7. Kyzer Subdivision; KPB File 2024-130 Edge Survey & Design / Carlson

# ITEM #7 - PRELIMINARY PLAT KYZER SUBDIVISION CARLSON ADDITION

KPB File No.	2024-130
Plat Committee Meeting:	December 16, 2024
Applicant / Owner:	Leif & Blanche Michelle Carlson / Kenai, AK
Surveyor:	Jason Young / Edge Survey and Design, LLC
General Location:	Kalifornsky Beach area / Kalifornsky APC

Aerial Map 1

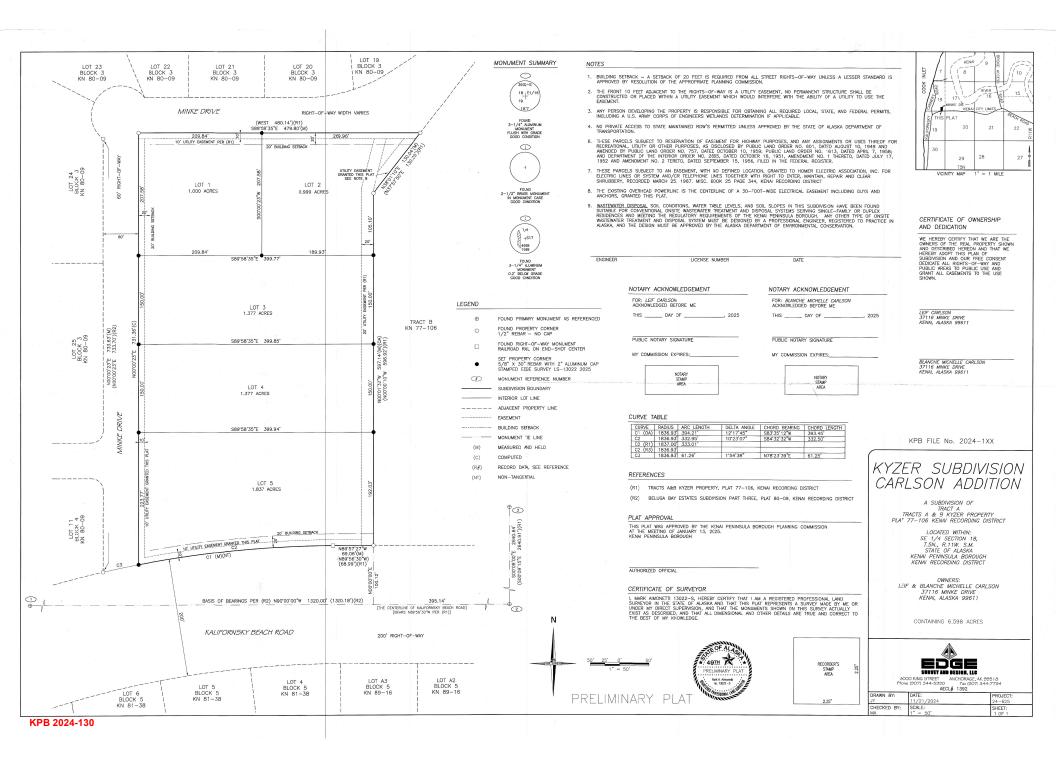
The land is relatively flat across the plat. there is a low area on the plat in the proximity between Lots 4 & 5. It shows up on the aerial photos but is not shown on the plat. this should be noted on the drawing as drainage from the east looks to be collecting in this pond. Staff recommends the surveyor should investigate the drainage issue further possibly.
